CLUTCH KIT	COVER ASSEMBLY	DRIVEN PLATE	RELEASE BEARING
		Ø ins/mm

YUGOCARS ▲1

FLYWHEEL CHANGE

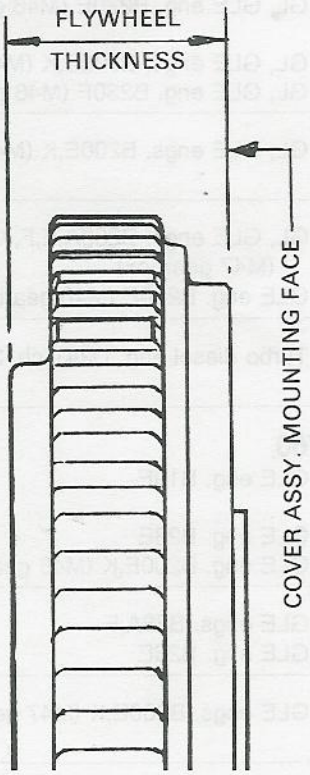
Both 1100 and 1300 cc. engines now use the standard 1100 flywheel which has a thickness of 28 mm.

The superseded 1300 flywheel, which is 31 mm thick, was fitted on most 513 models produced between 1983 and 1987. Because of the difference in flywheel thickness it is most important that the correct clutch cover assembly is fitted.
